**P&Z STAFF REPORT**

Case: **V19-0022 – 0 Glenridge Drive**  
Staff Contact: Madalyn Smith (msmith@sandyspringsga.gov)  
Report Date: December 3, 2019

Requests for the following Variances for the purpose of developing a hotel at 0 Glenridge Drive:

1 LEVEL 1 - LOBBY - D.C. - 8.1.10.C.3  
AA1.19A SCALE: 3/64" = 1'-0"

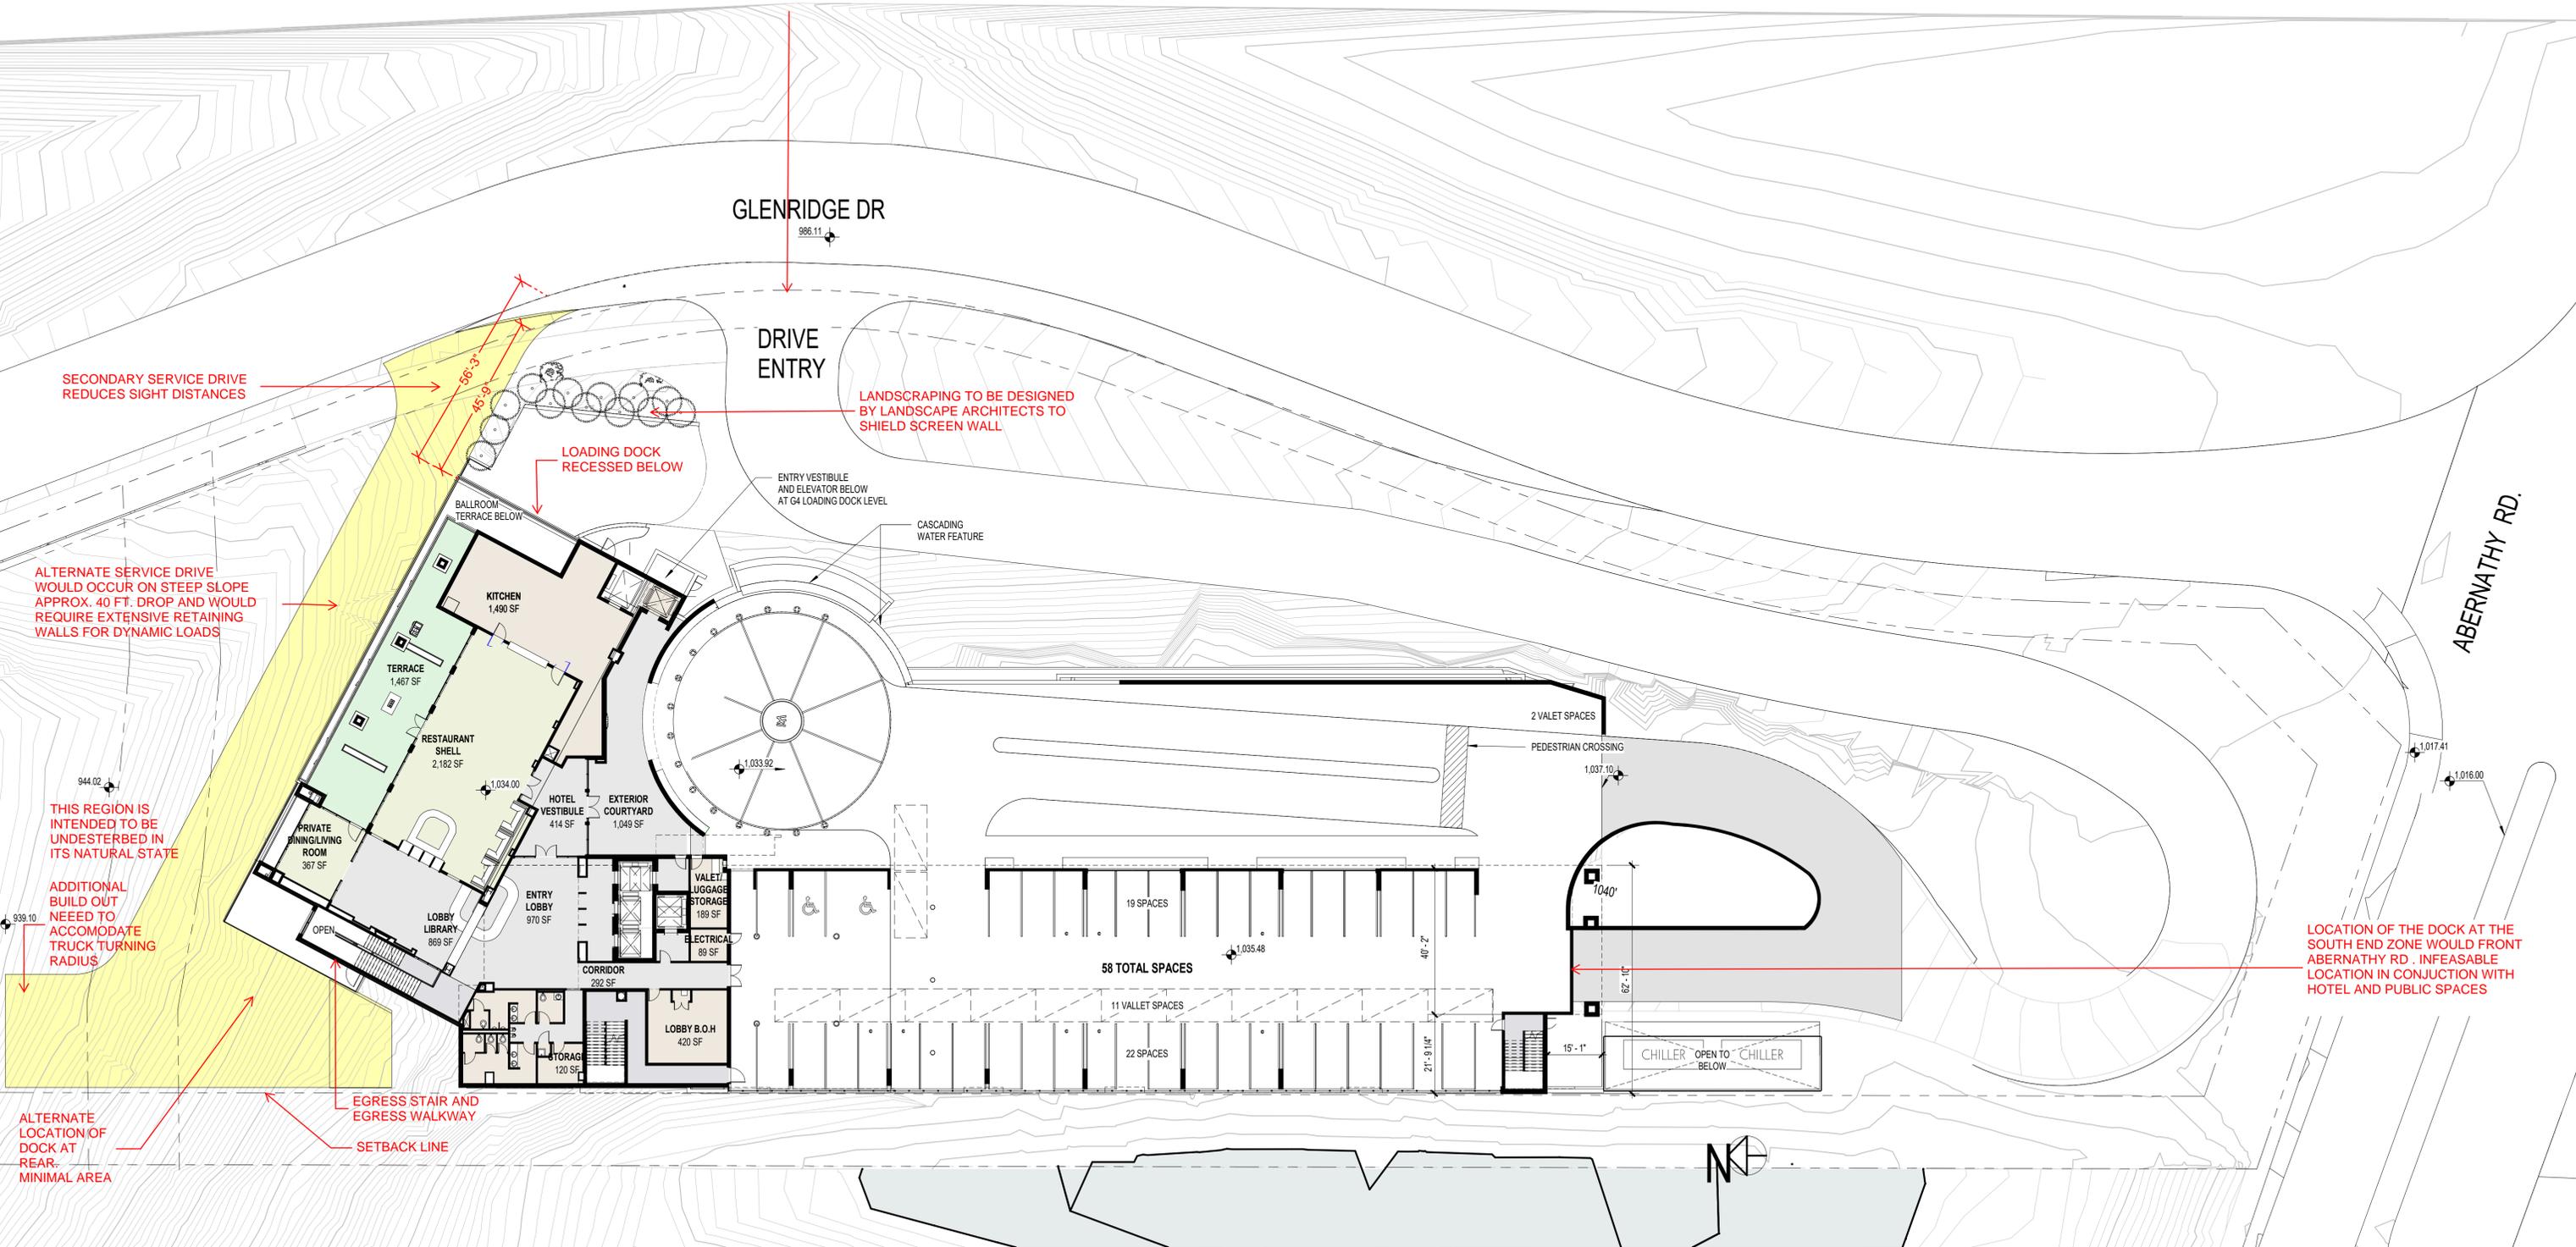
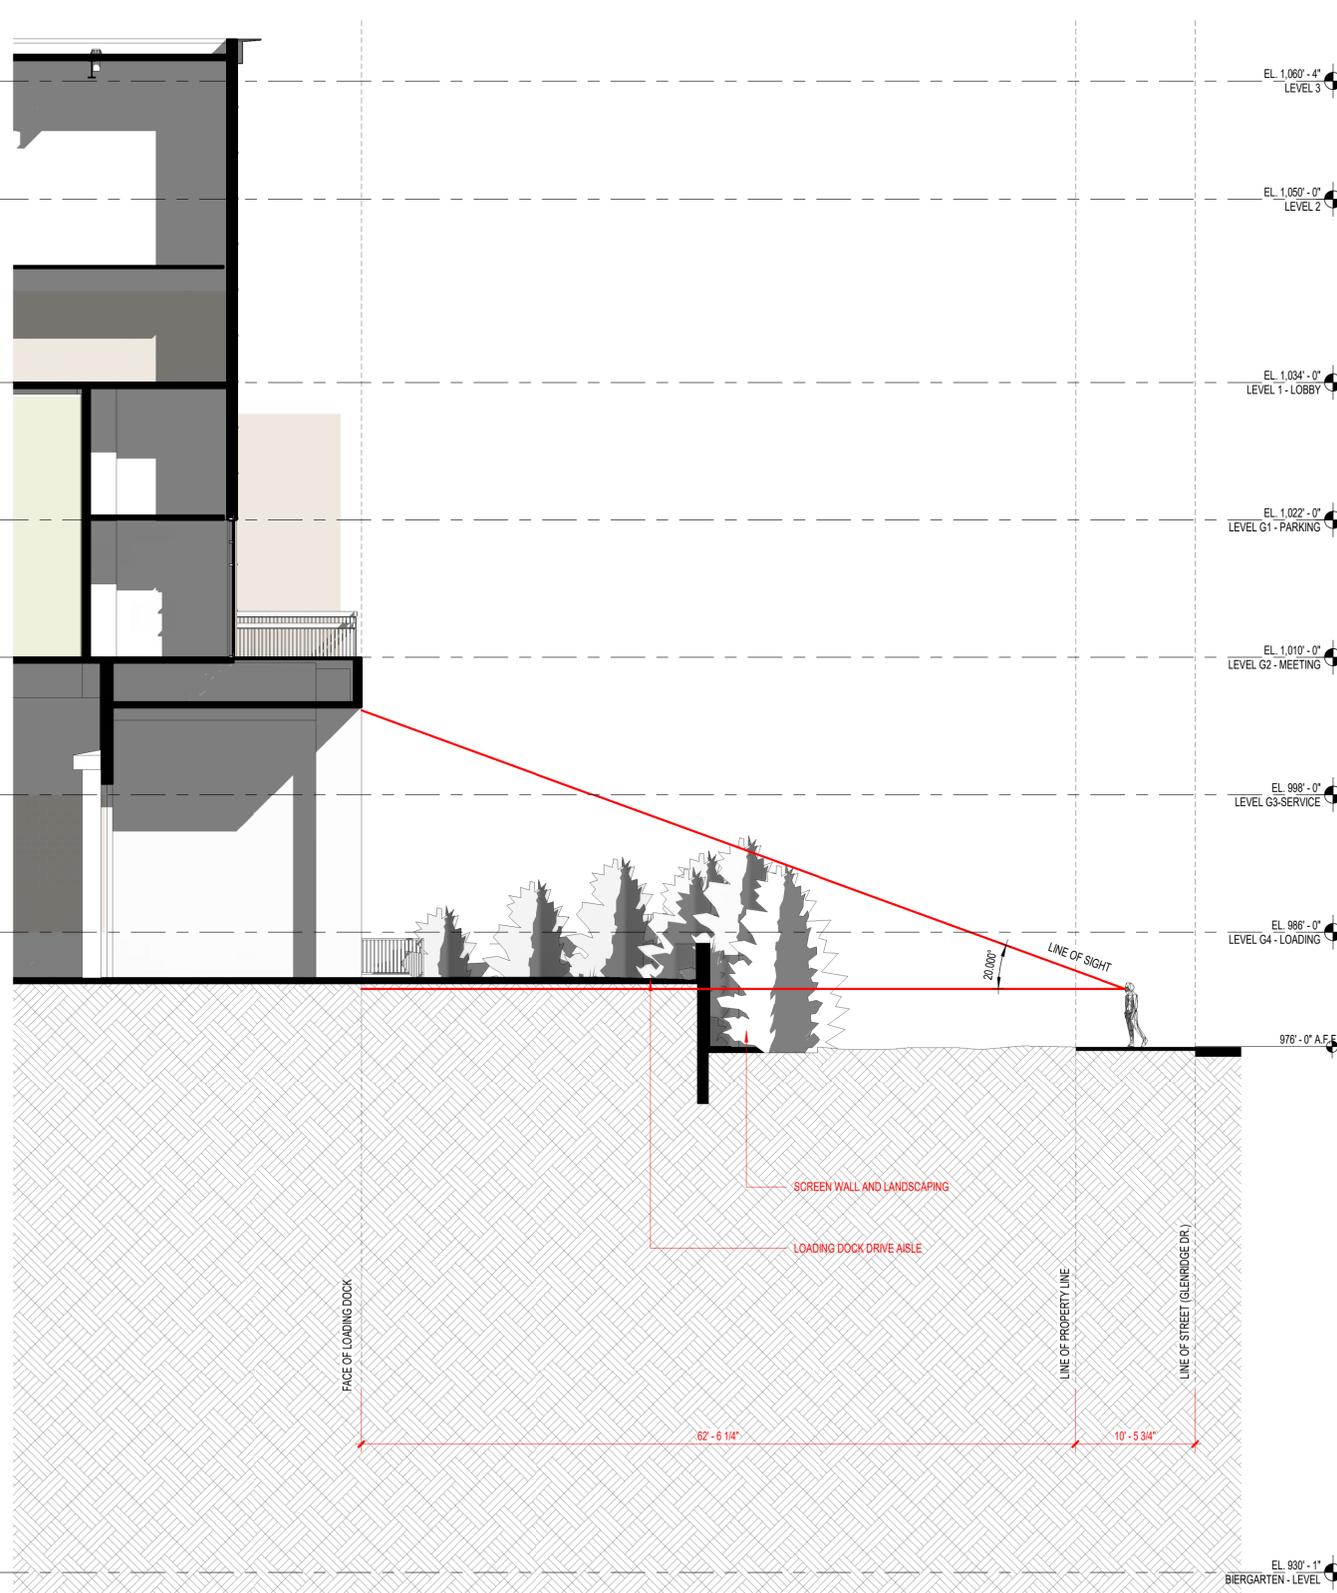
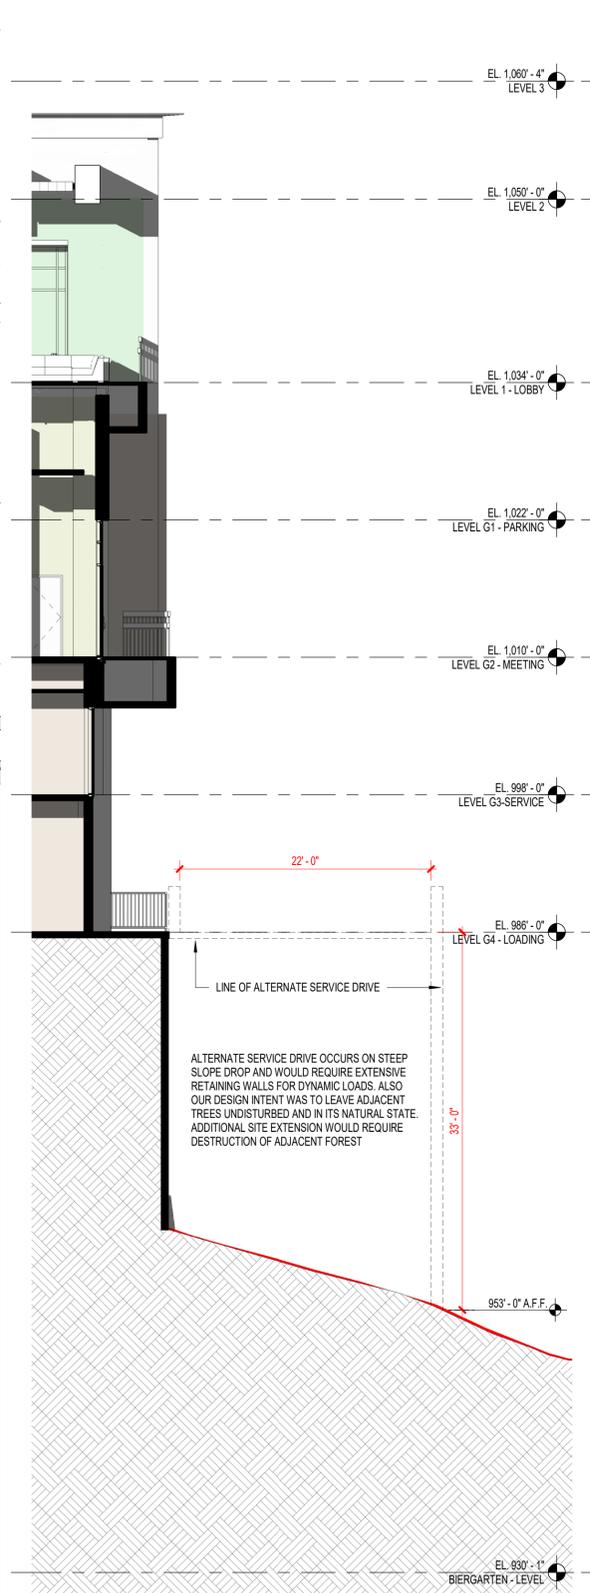
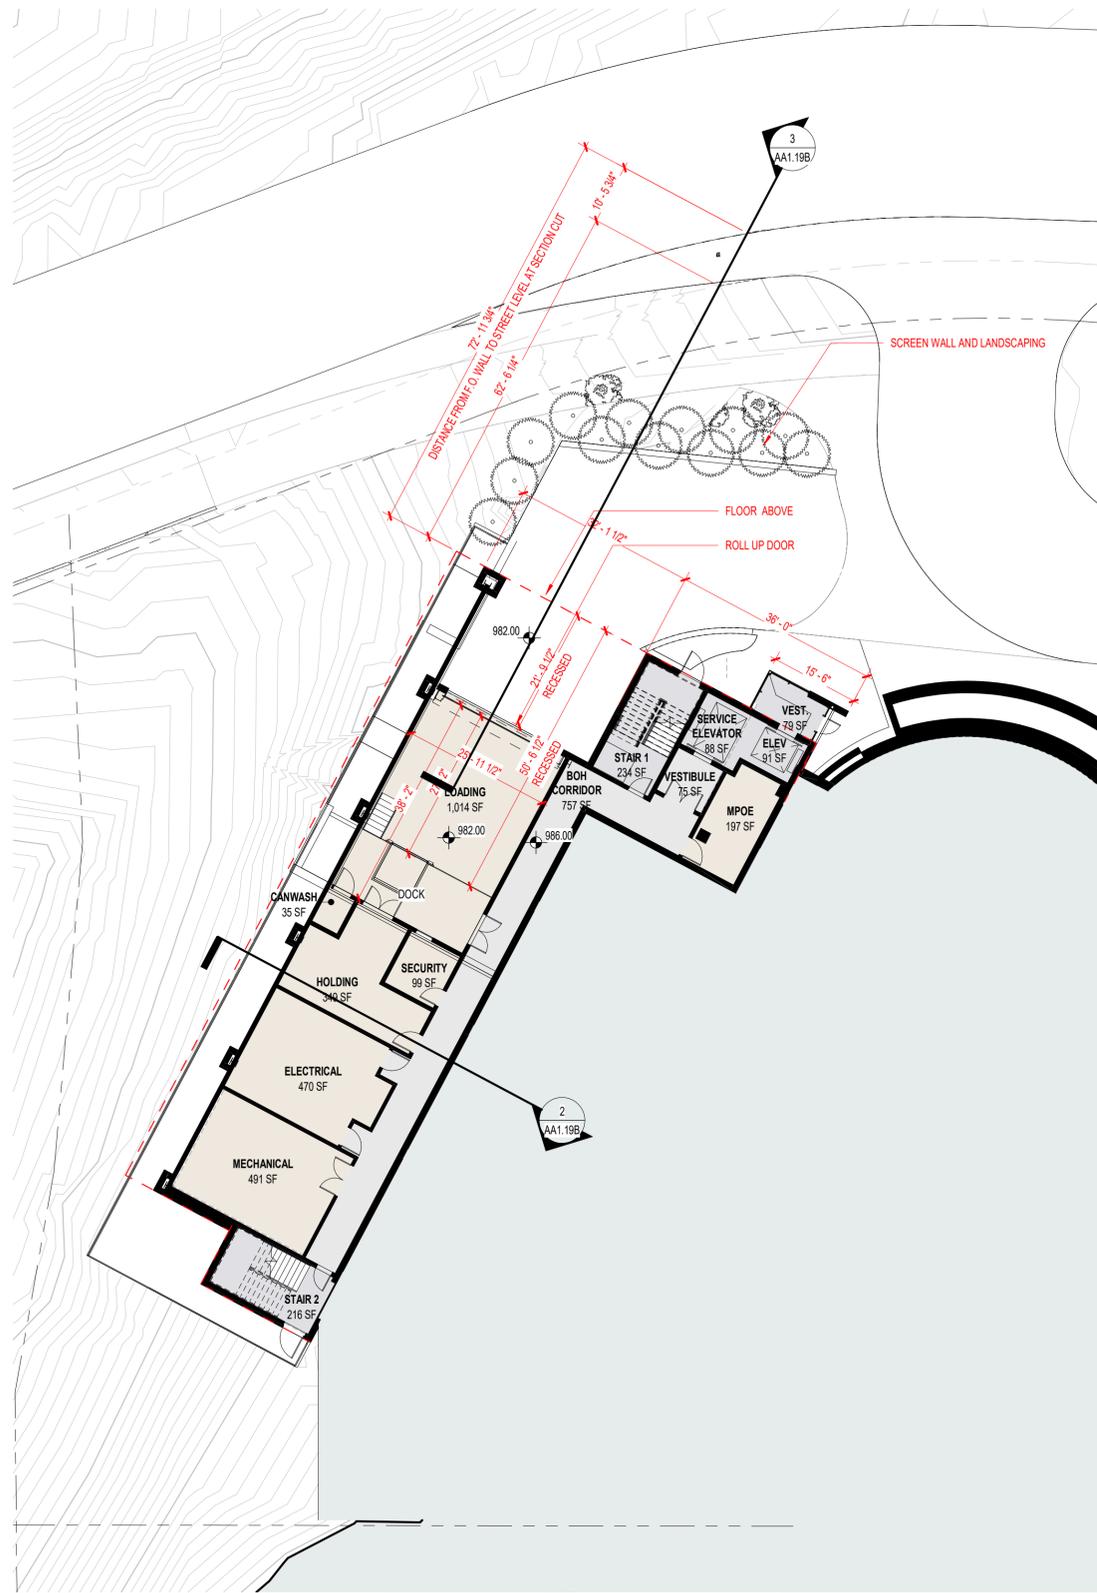
The location and orientation of the loading dock also seems to be the only practical solution. The alternative location appears to create much more site disturbance, create difficult access issues and put the loading dock activities directly adjacent to a residential use.

1. The location of the loading dock be substantially similar to that shown on the “*Mayson House Variance Issuance*” plans received October 28, 2019 and subsequent amendments received November 6, 2019.
